STAFF RECOMMENDATION
916 Boscobel Street
August 16, 2017

Application: New construction—Setback determination
District: Edgefield Historic Preservation Zoning Overlay
Council District: 06
Map and Parcel Number: 08216035200
Applicant: Cheyenne Smith
Project Lead: Melissa Baldock, melissa.baldock@nashville.gov

SITE PLAN

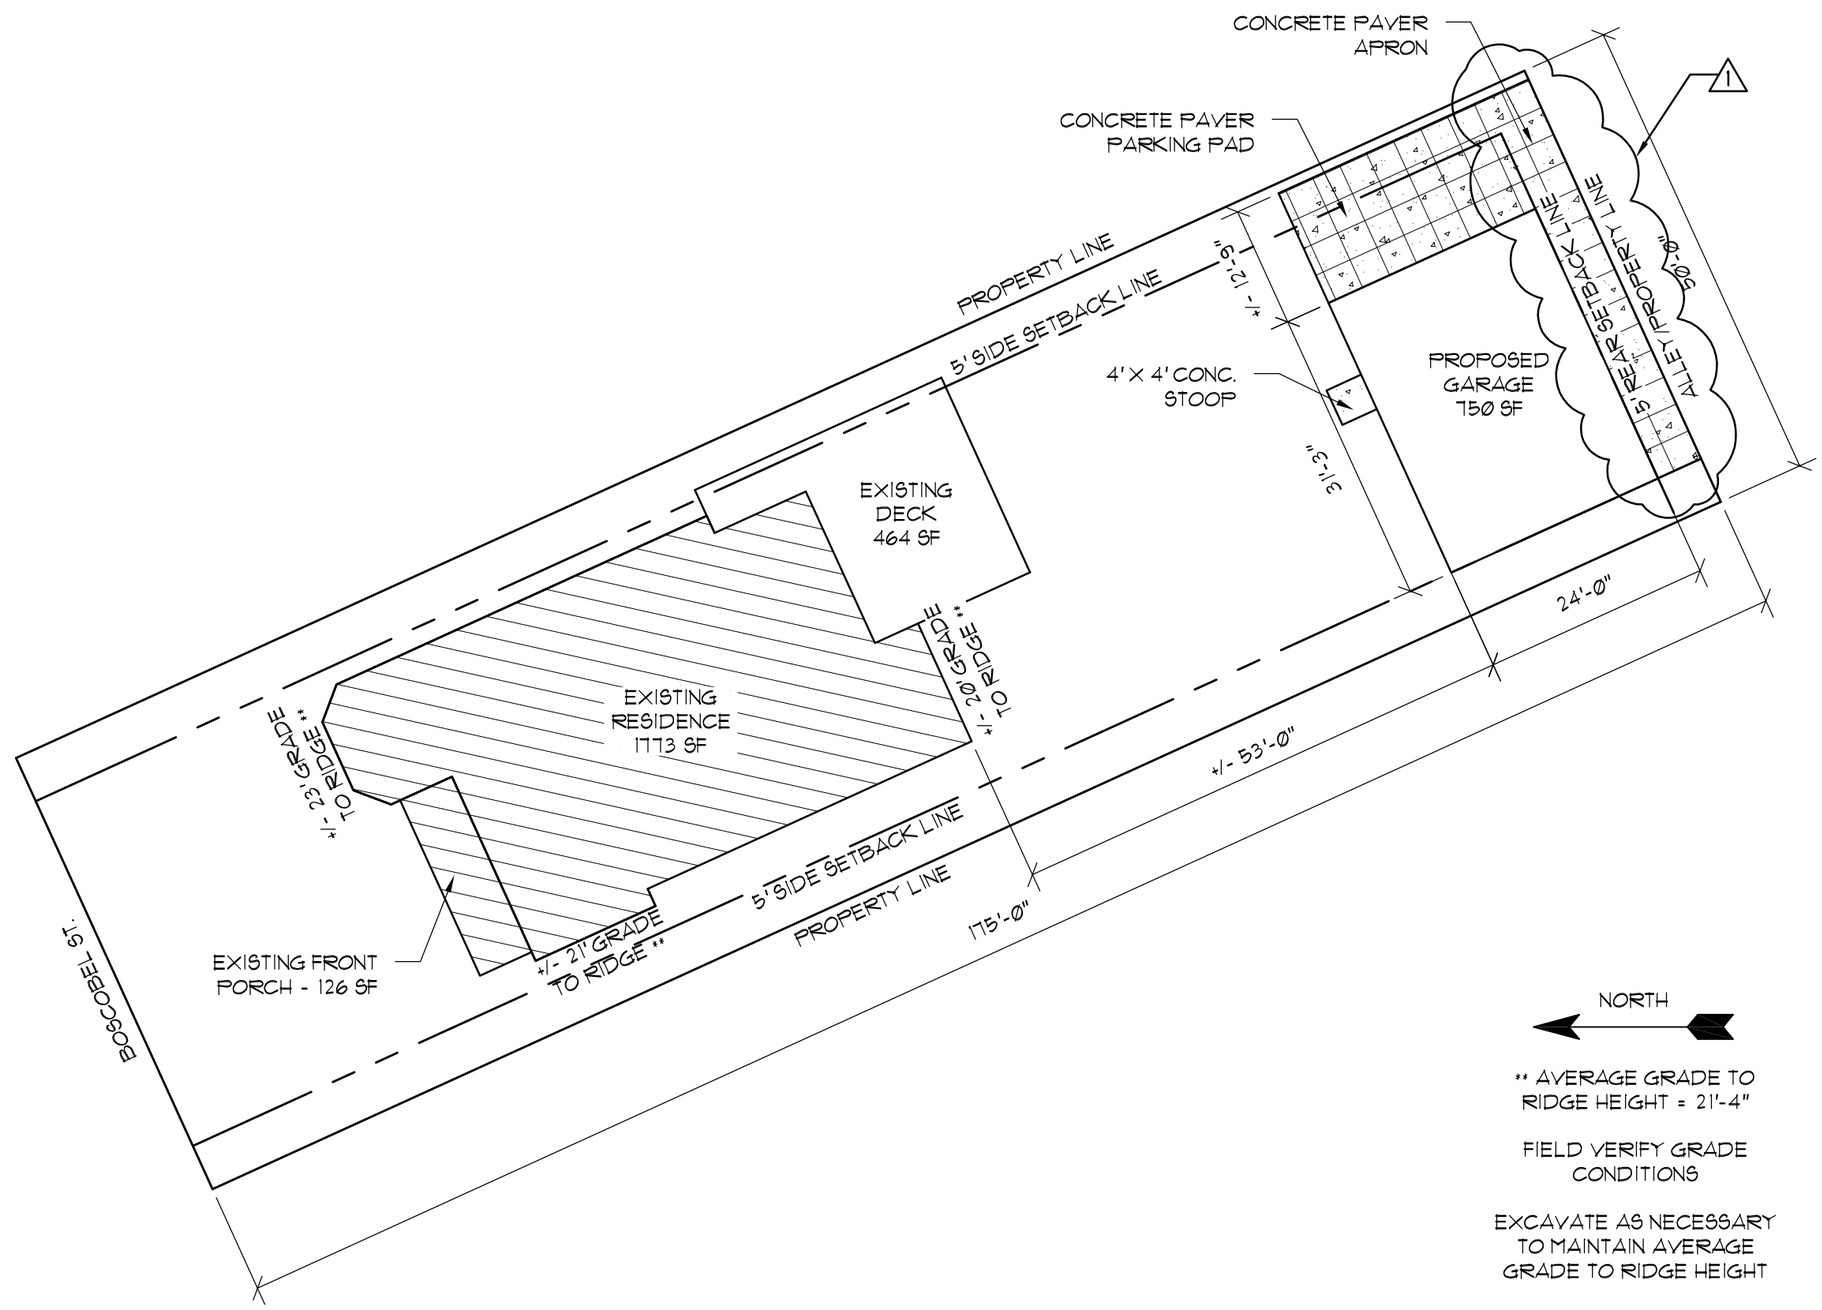
Analysis and Findings: Application is to reduce the rear setback for a previously-approved Detached Accessory Dwelling Unit (DADU). MHZC approved a ten foot (10') rear setback in August 2016, and the applicant now seeks a five foot (5') rear setback. The design, height, scale, roof form, and other detailing has not changed since the approval in 2016, and the Commission does not need to review these parts of the application at this time. Staff has received a copy of the filed restrictive covenant for the DADU.

*The new DADU does require a rear setback determination. In August 2016, MHZC approved a ten foot (10’) rear setback for this DADU. When an outbuilding has a footprint greater than seven hundred square feet (700 sq. ft.), base zoning requires that the structure be located twenty feet (20’) from the rear property line and five feet (5’) from the side property lines. In this instance, the structure is located at least five feet (5’) from the side property lines. In 2016, MHZC determined that a ten feet (10’) rear setback was appropriate and met both the DADU Ordinance and the Design Guideline.

Staff finds that the currently proposed rear setback of five feet (5’) is also appropriate and meets the DADU Ordinance and the design guidelines. MHZC has determined in previous decisions that in residential neighborhoods like this one, a five foot (5’) rear setback for outbuildings with garage doors facing the alley is appropriate. Historically, outbuildings were located at the rear of the property, close to the rear property line. In addition, the five foot (5’) rear setback allows for more space between the primary structure and the outbuilding. Staff recommends approval of the setback determination.

Recommendation Summary: Staff recommends approval of the detached accessory dwelling unit’s rear setback, finding that it meets Ordinance 17.16.030. G. and Sections III.B.2.a. and III.B.2.h of the Edgefield Historic Preservation Zoning Overlay design guidelines.
